DFS T Galleria Sydney

Department of Planning responses to support SSDA

Application # 6715

Signage & floor finish proposals/clarifications

Amended/Proposed George St entry, Floor finishes & signage

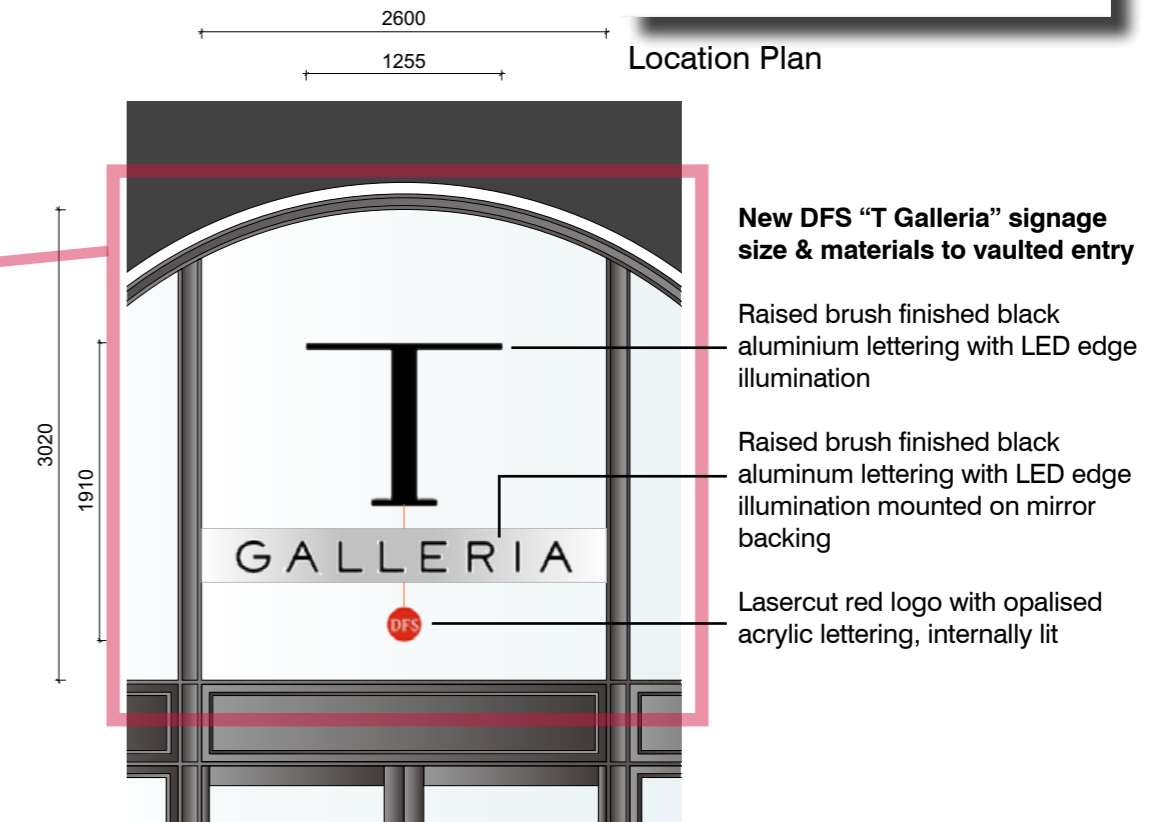
Amended transitional tile selection to George Street entrance & proposed overhead internal vaulted entry signage
Refer Proposed George St signage elevations, noting recessed vaulted entry doors & signage are located beyond street facade

Proposed George St external facade signage

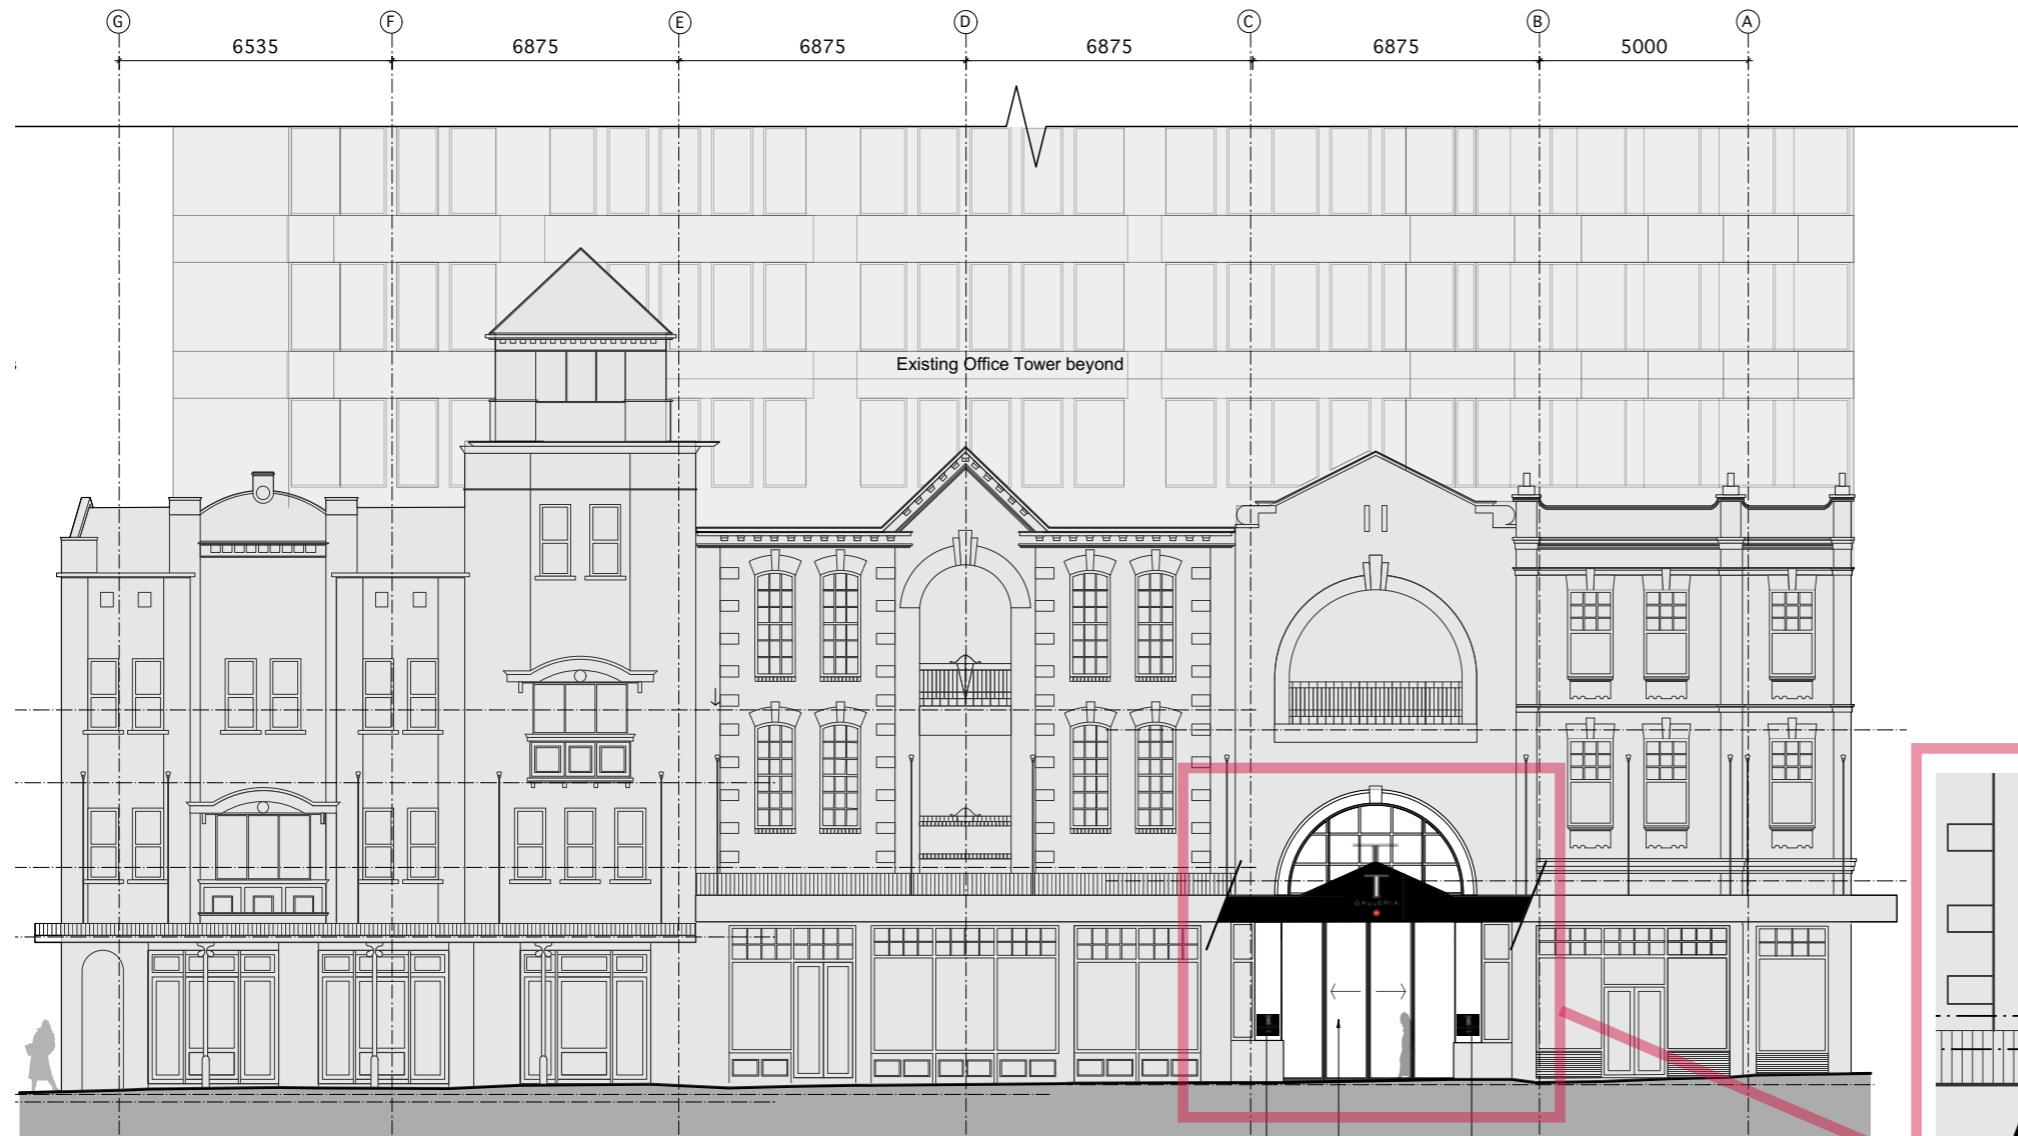
NOTE: Existing folded metal (black) awning fascia trim & finish to remain.
Contractor to allow for make good and clean upon completion of works

New non-illuminated DFS "T Galleria"
enamel finish brand signage on pin
fixed steel plate to either side of existing
rendered and paint finished columns
Size approx. 550 x 550mm (top edge
mounted @ 1800mm AFFL

Enlarged view - Proposed George St signage -

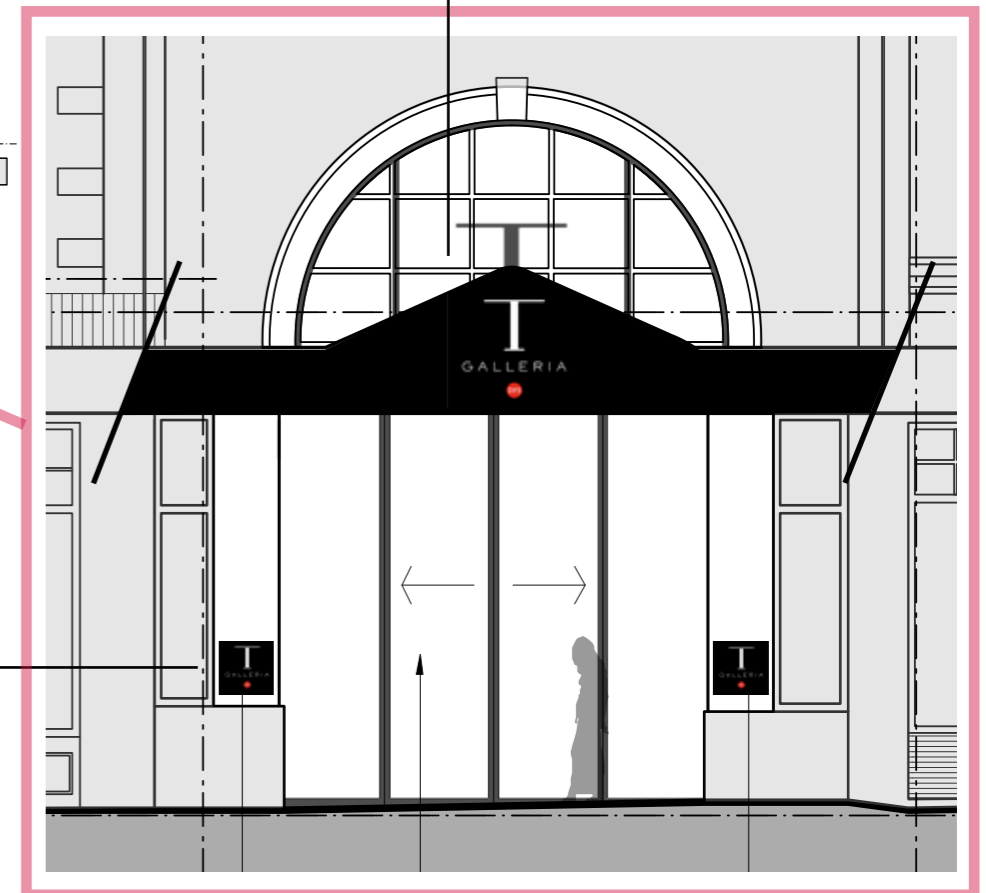
Update existing applied DFS awning
fascia lettering with new non-illuminated
DFS "T Galleria" branding - Size approx.
650 x 650mm (check on site to fit existing
fascia profile)

Proposed Harrington St Facade signage (new & modifications to existing)

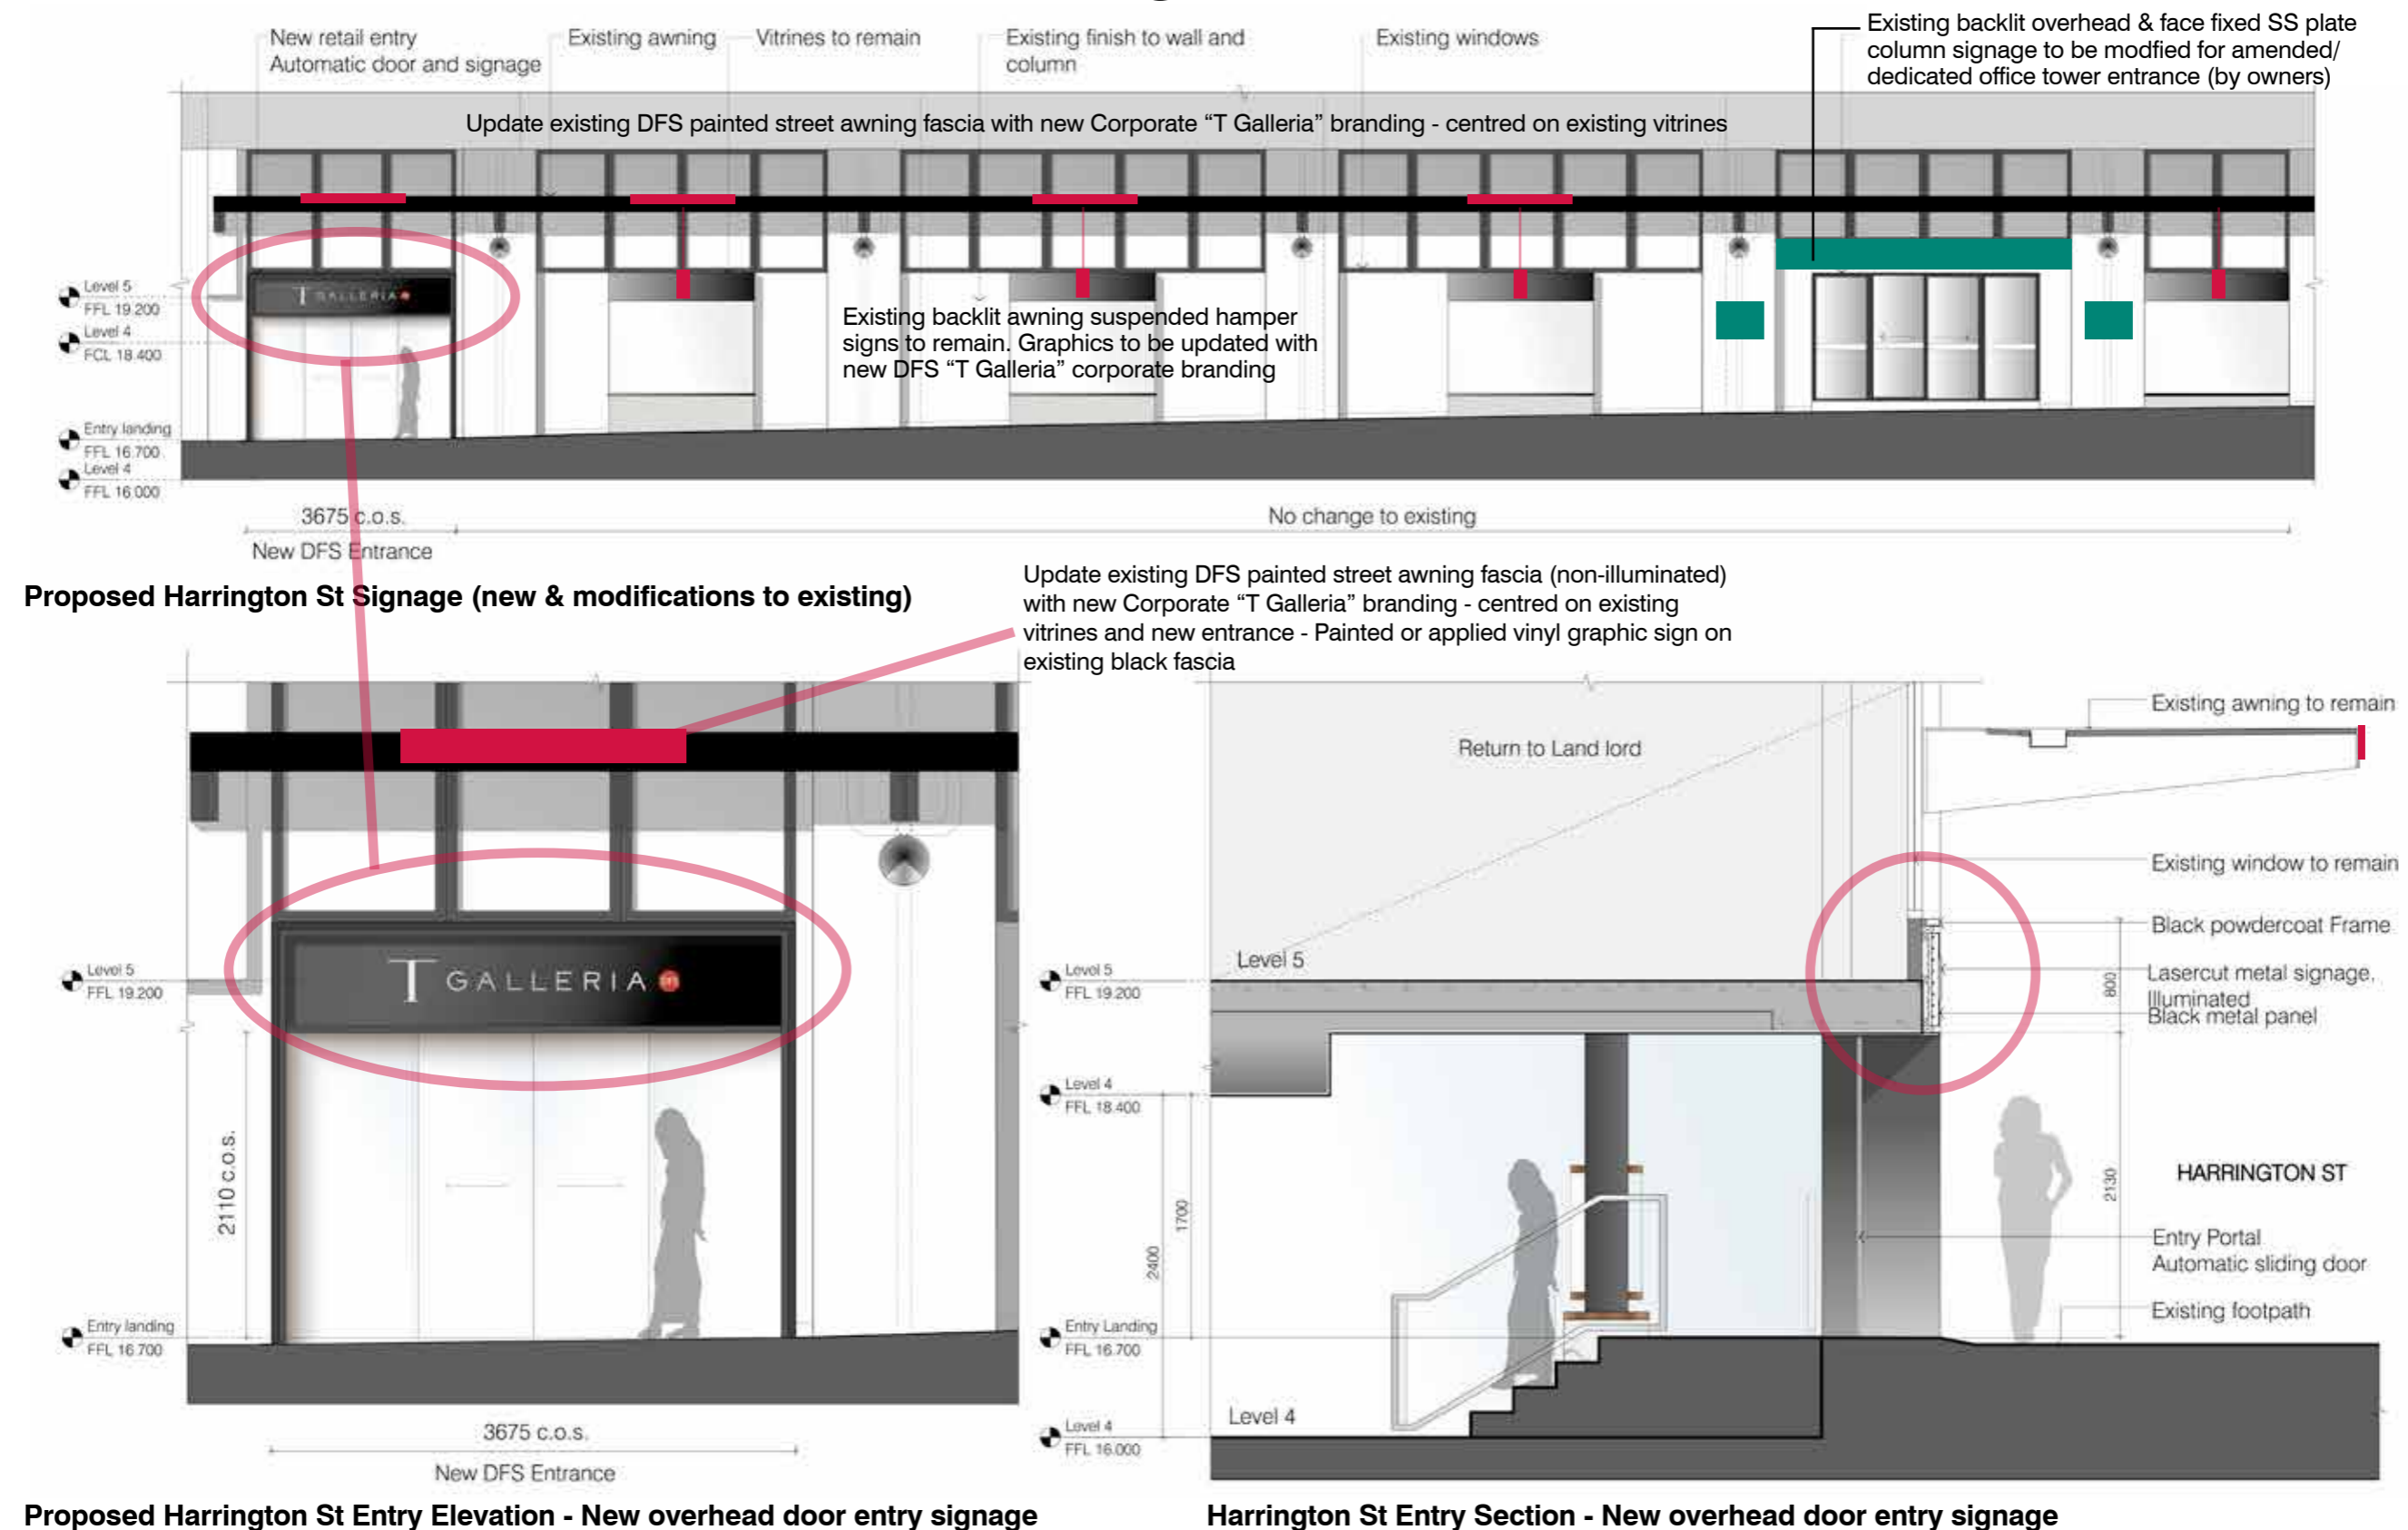
Existing backlit under awning suspended hamper signs to remain - hamper signs located opposite existing street retail display vitrines (also to remain)
